GEOCRES No. 30M5-62DIST. 4 REGION W.P. No. 170-67-01
(former 195-58-00)CONT. No. 76-128W. O. No. STR. SITE No. 10-194HWY. No. 403LOCATION Waterdown Rd.
Retaining WallNo. of PAGES -

W.P. 170-67-01, Site No. 10-194
Proposed Retaining Wall
Waterdown Road Underpass
Highway 403, District No. 4

W.P. 170-67-01 Interchange at
C.A.H. 403 and Waterdown Road
Br. #12 - original W.P. 195-58-01
Proposed Retaining Wall

A RETAINING WALL AT HIGHWAY NO: 403

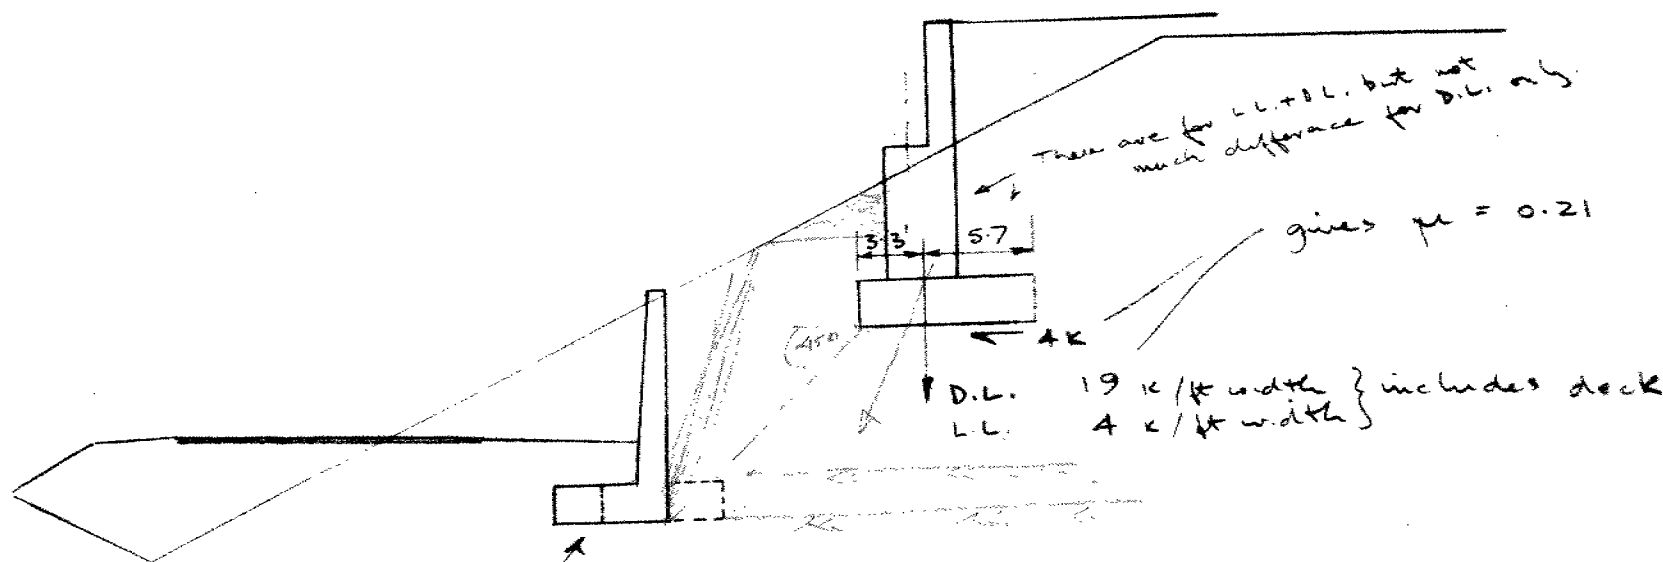
As suggested in the above memo, would you please check the factor of safety of the abutment against sliding and also confirm that the proposed location of the retaining wall is quite in order at your earliest convenience?

I am also enclosing a copy of the sketch showing the proposed location of the retaining wall with relation to the abutment.

Retaining wall this slope would slide
Assume dotted shape

Passive pressure of soil in front of abutments is not considered. In this case the friction on the base is well below the permissible value.

The scheme is obviously feasible. I assume that the doubt in your mind is whether shoring will be required. It seems to be a rather early stage to consider such details, but I have sent to K. Selby the data he needs to investigate this.

Figures shown are approximate and
unchecked but should be good enough for your purposes.
If accuracy is important we can get exact figures later
during design stage.

SKETCH SHOWING PROP. RETAINING WALL IN
NORTH-END SPAN OF THE FREEWAY
UNDERPASS AT WATERDOWN RD.

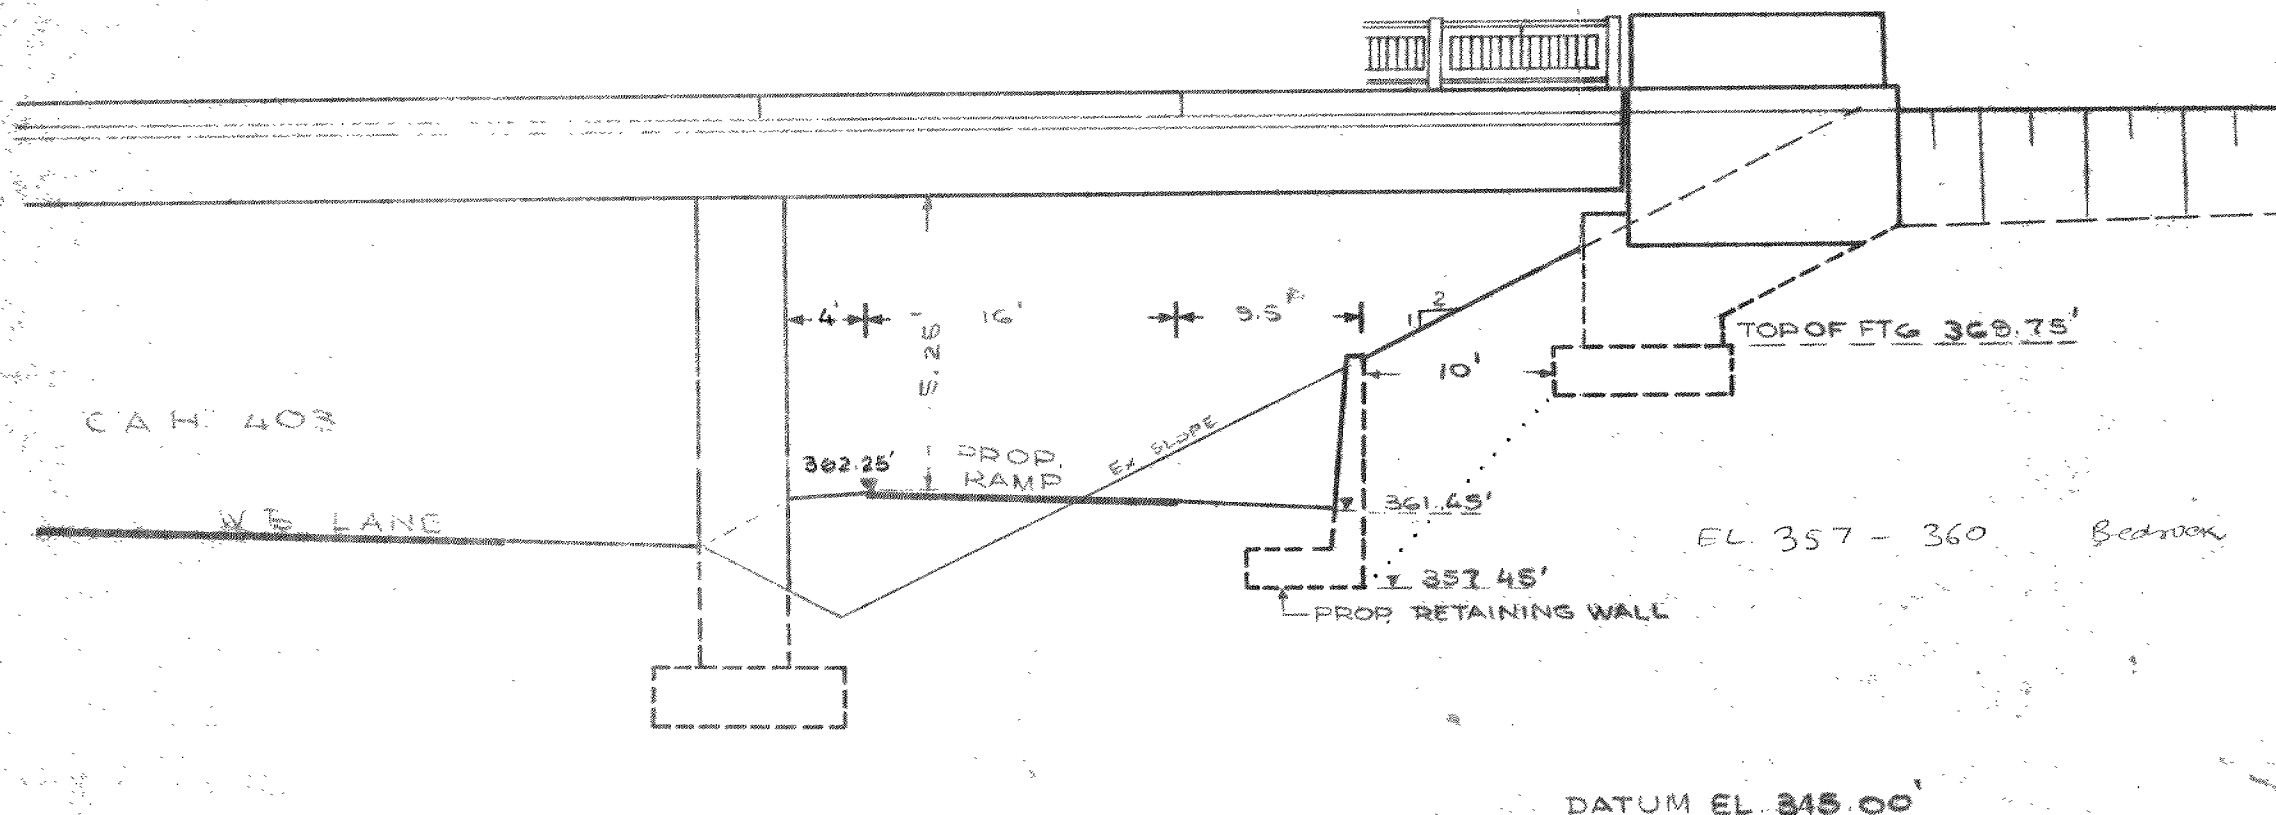
As a result of the above discussion, I am now enclosing a sketch showing the elevation of the end span of the above bridge and also my proposed location of the retaining wall.

Would you kindly investigate the feasibility of this proposal and let me have your comments at your earliest convenience?

As requested, we have reviewed your proposal for the abovementioned retaining wall as shown on the sketch attached to your memo dated December 14, 1970. We are of the opinion that the wall can be constructed without detrimental effect on the existing abutment, provided that removal of soil in front of the abutment footing will not drastically reduce the safety factor of the abutment against sliding. Normally passive resistance is neglected in the design, but it would be as well to check with the Bridge Office whether this is actually the case.
